END OF ADDENDUM NO.2

Project
PHASE1: SHSC GIM Decant (K2E)
PHASE2: SHSC Renovation of C2 Decant (K3E)

Project No. HS1024-0383

1 ARCHITECTURAL ROOF PLAN
A20-RF SCALE: 1 : 100

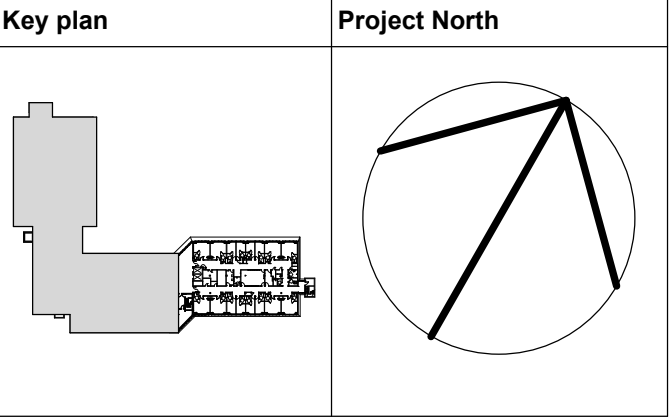
1.4.2 Drawing A20-RF – Roof Architectural Plan

- 1.4.2.1** Updated AHU to match mechanical dwg and added reference to platform stair.

1 LEVEL 2 - FINISHES FLOOR PLAN

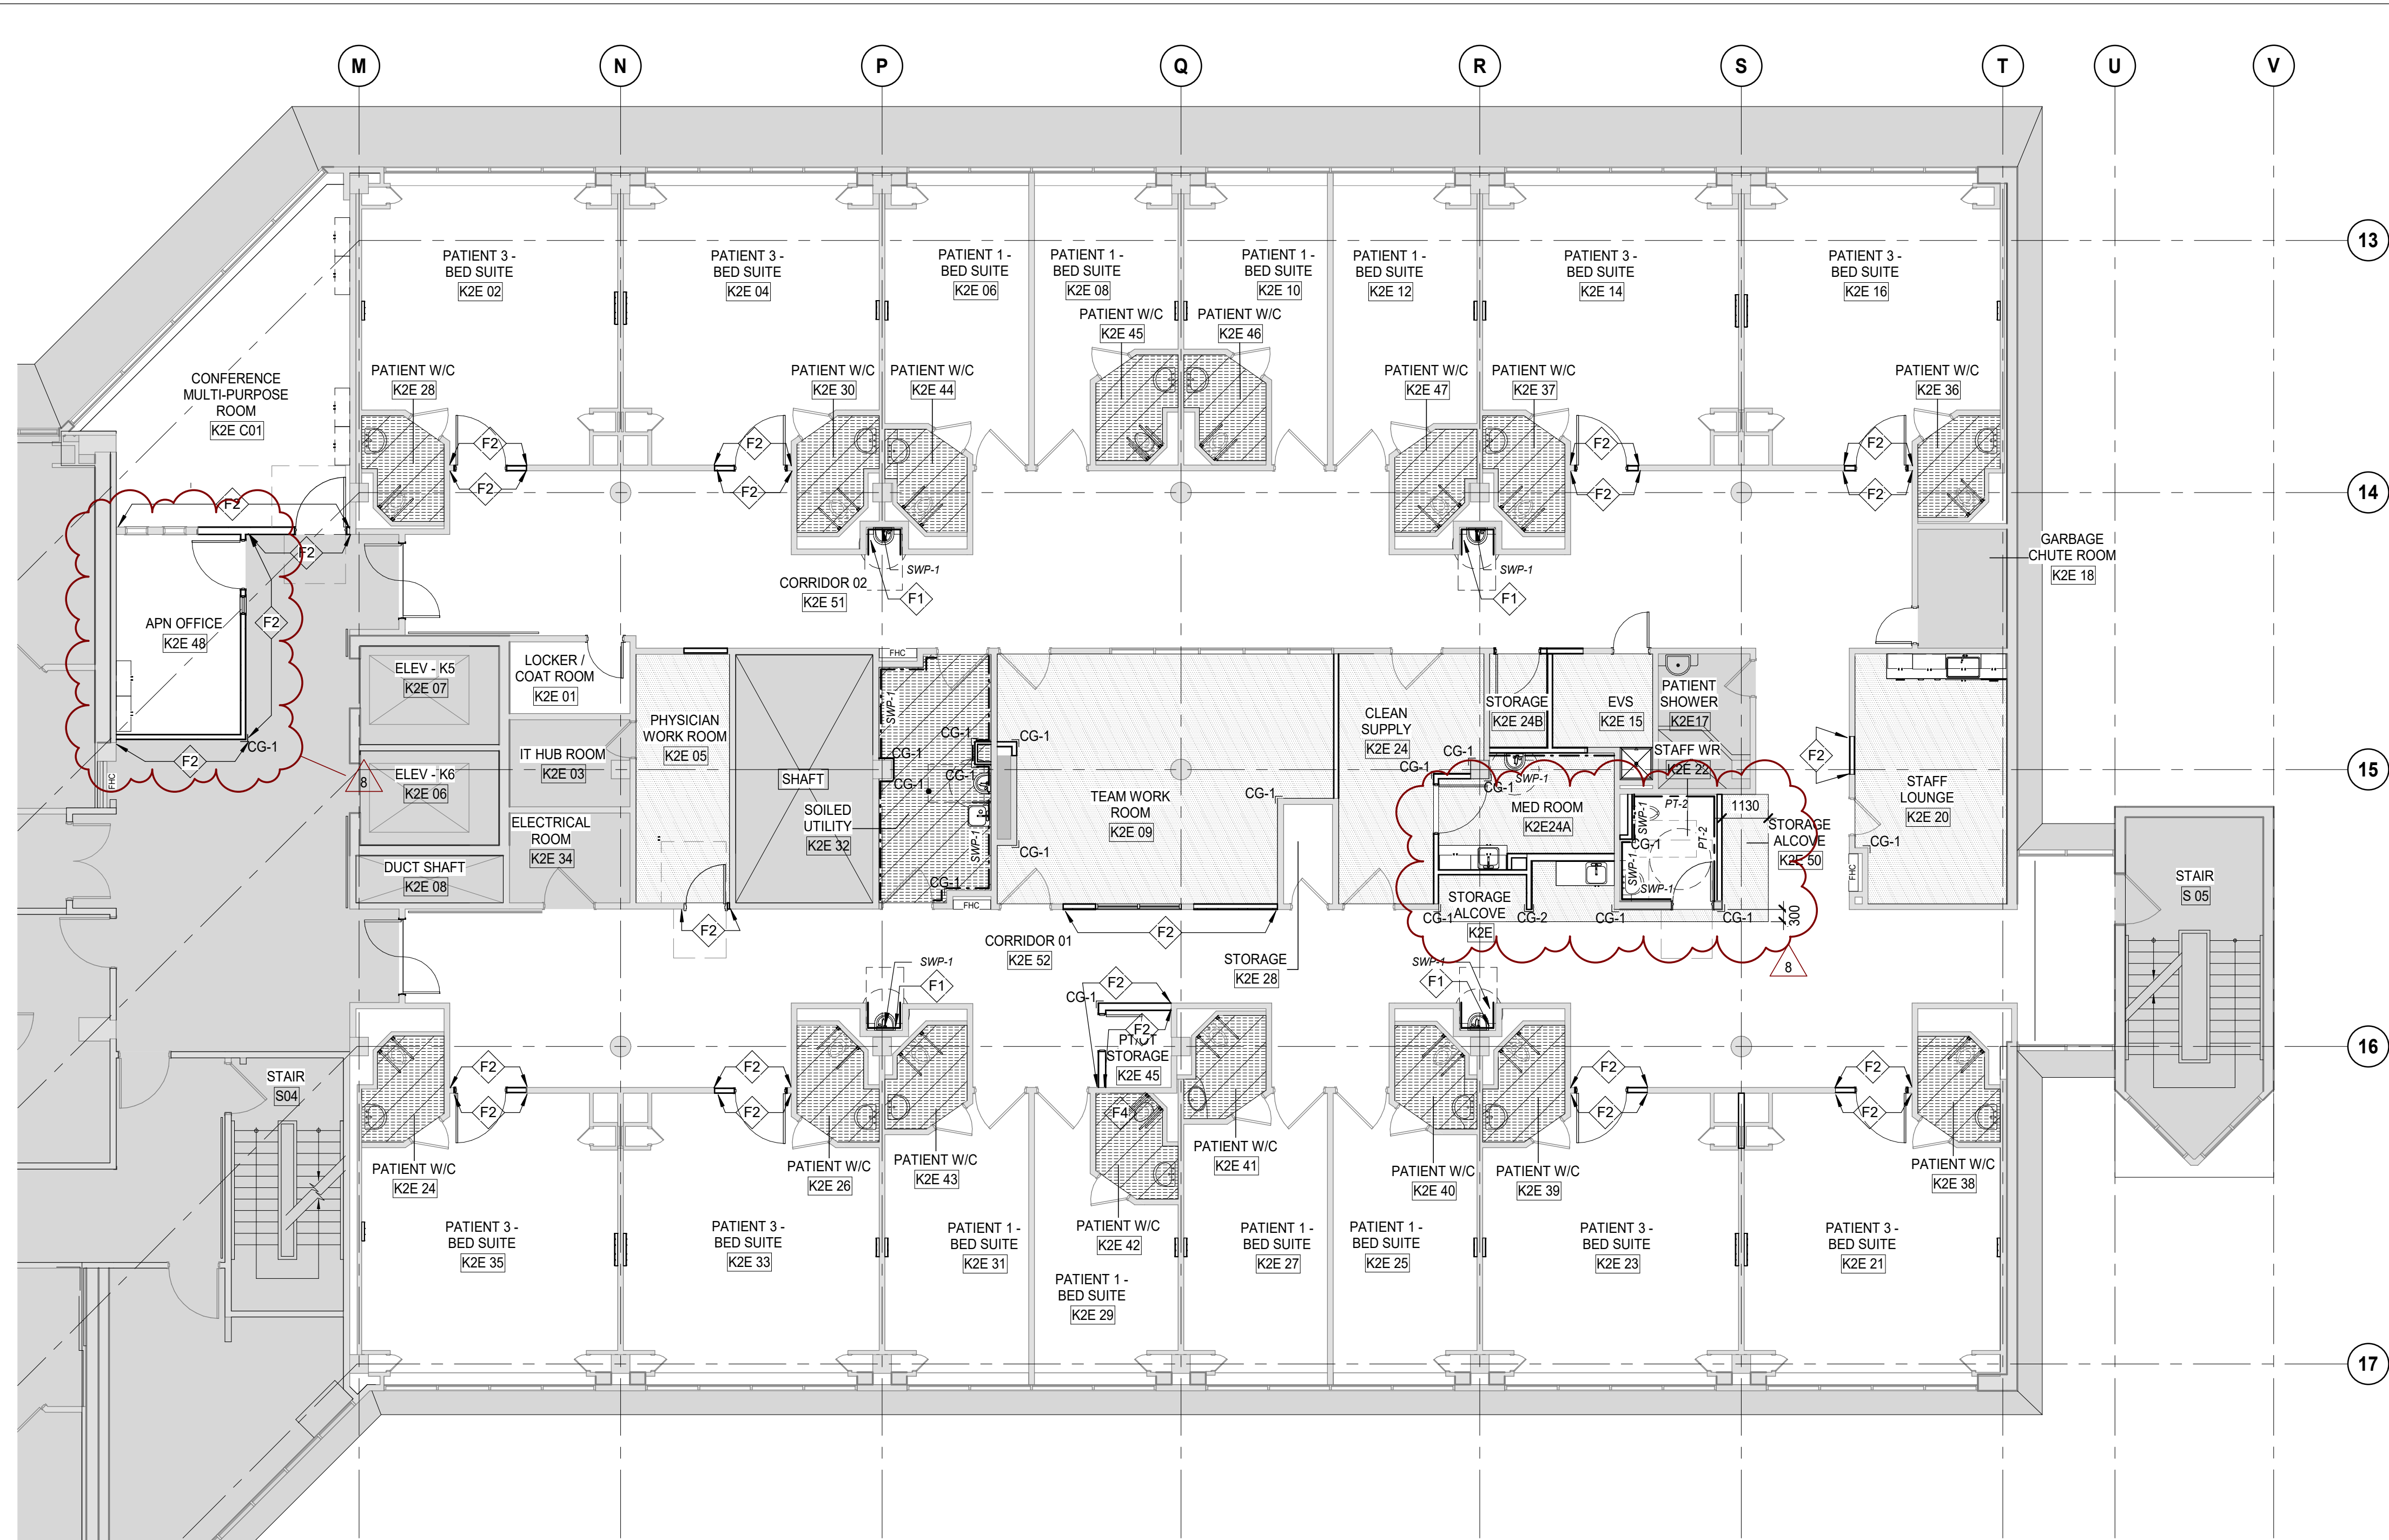
1.4.3 Drawing A22-01 – Level 2 Finish Floor Plan

- 1.4.3.1** Updated Room Finish Schedule, floor plan, general notes and finishes legend.

1.7.21 Question: As Floor finish however the floor finish plans drawing shows/hatched to receive RSF-1 so please confirm if these are to be included for new RSF-1 flooring or existing to remain. Room numbers are #K3E05, K2E48, K2E09, K2E05, K2E24B.

1.7.21.1 **Answer:** A22-01 & A22-02 updated.

1.7.43.1 **Answer:** Confirmed, Room Finish Schedule is updated on Dwg. A22-01.

13 ROOF STAIR SECTION
A71-01 SCALE: 1 : 20

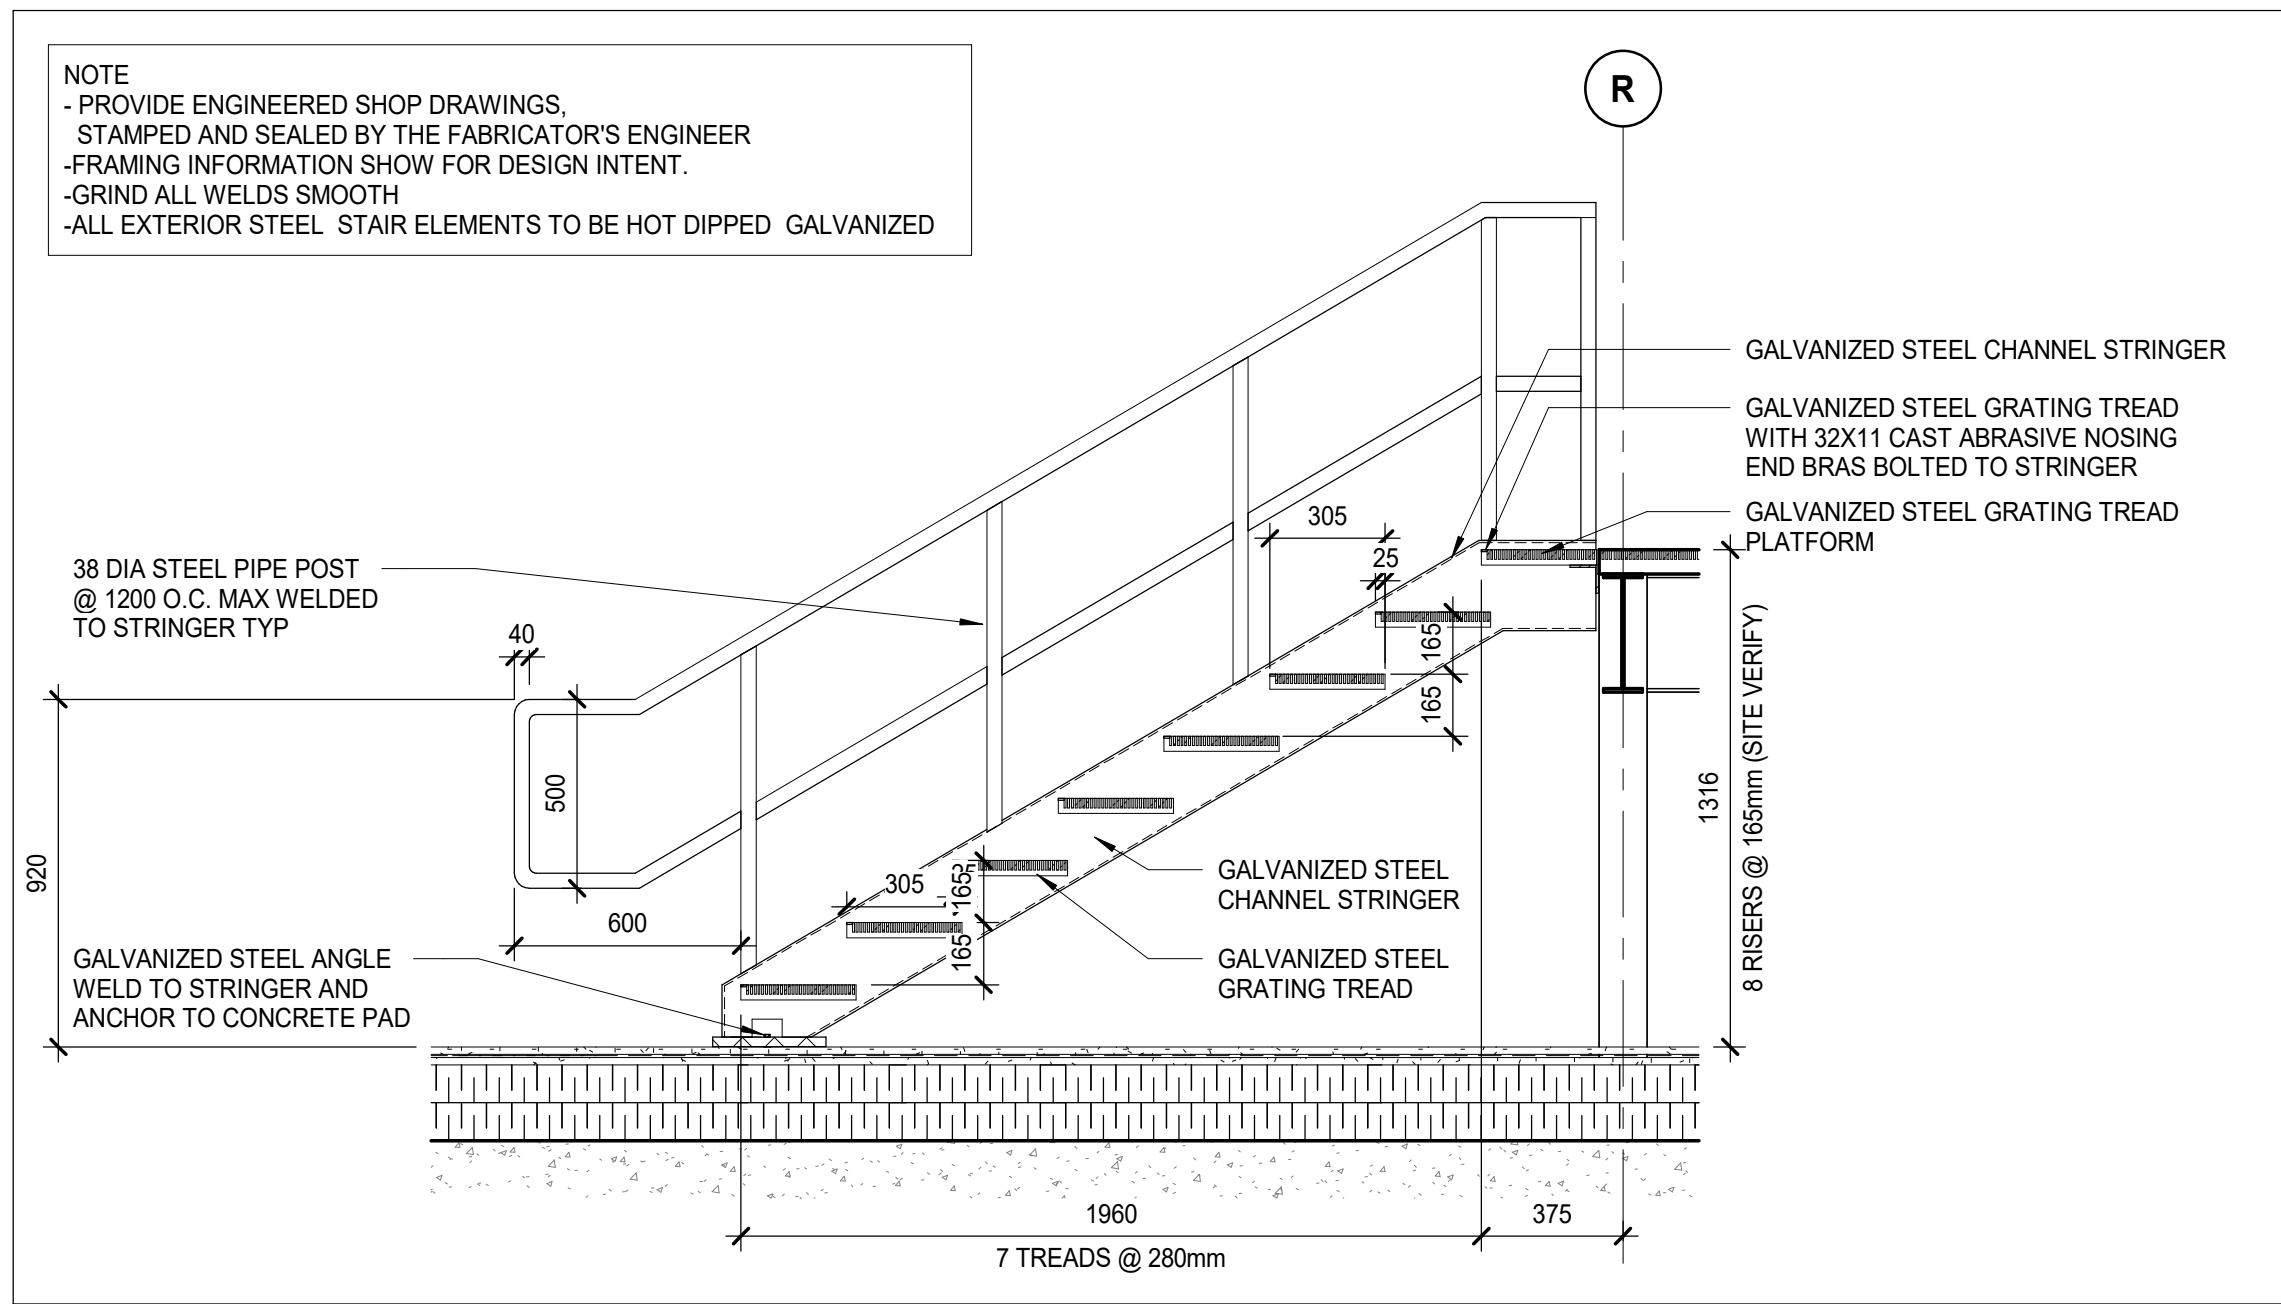
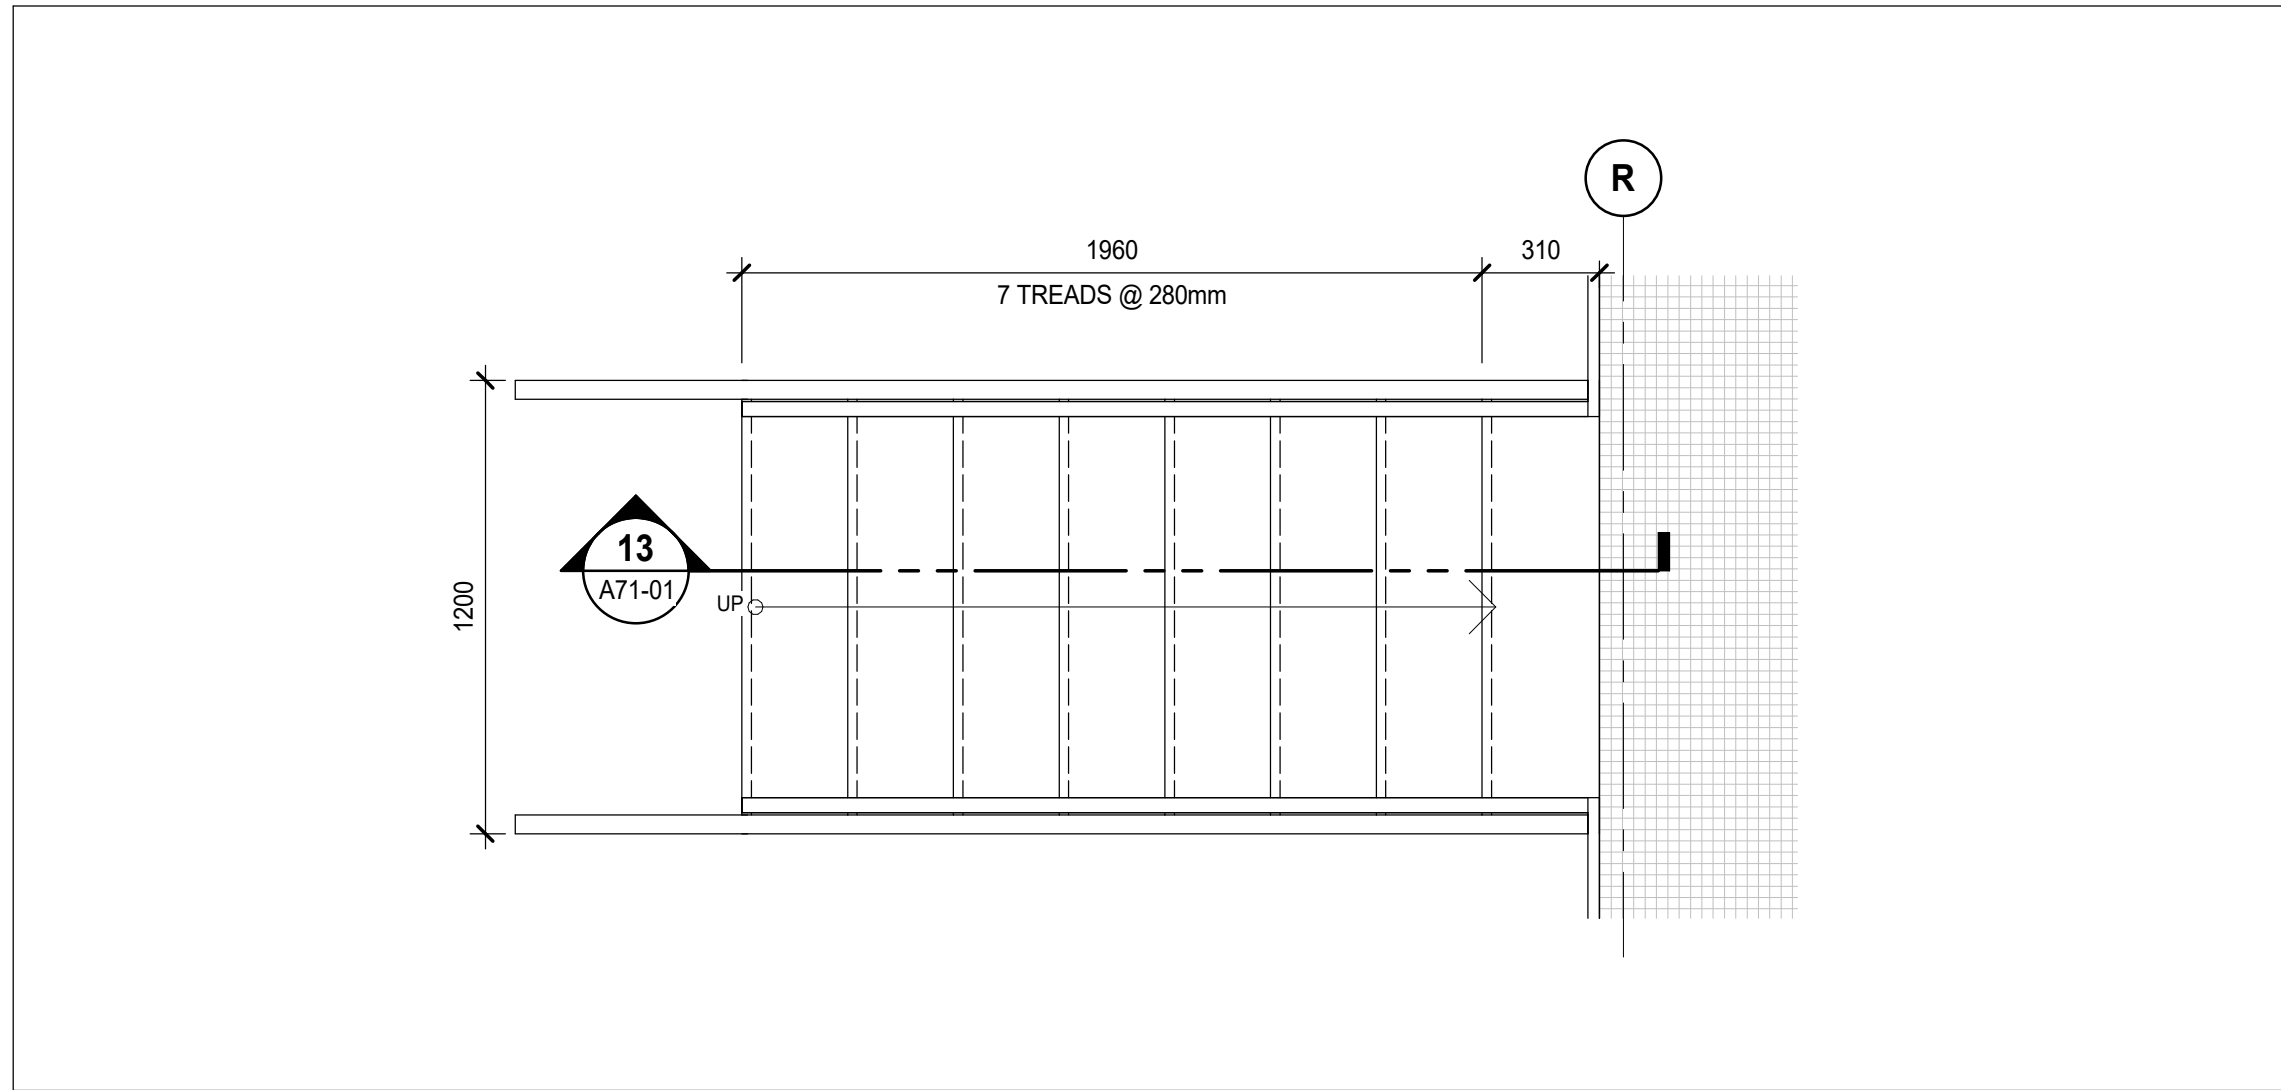
1.4.5 Drawing A71-01 – Plan Details

- 1.4.5.1** Added details 12 & 13.

1.7.49 Question: Please provide details for Roof stair and railing mention in Structural drawings.

1.7.49.1 **Answer:** Details added to Architectural drawings A20-RF & A71-01.

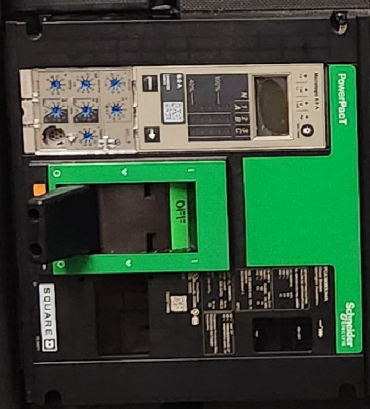
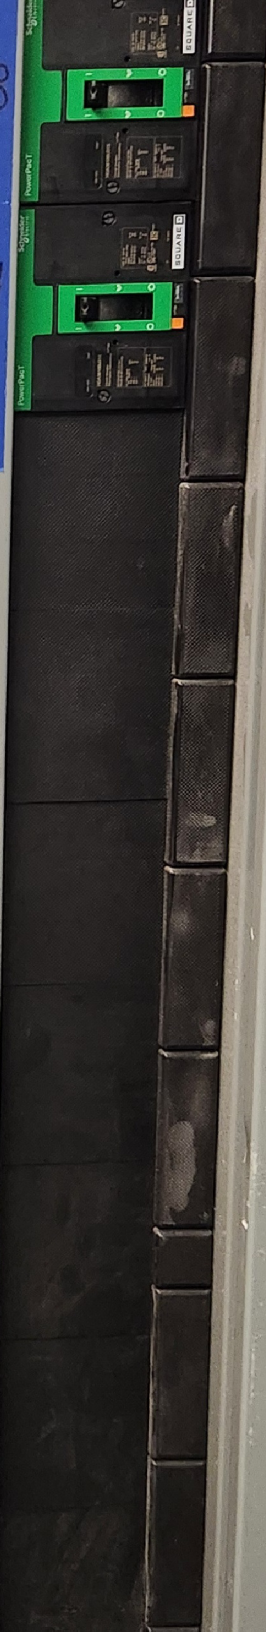
Could you please confirm whether you have a photograph of the existing Distribution Panel in Substation #16, specifically showing the breaker and manufacturer information? If not available, kindly request that the consultant provide one at their earliest convenience.
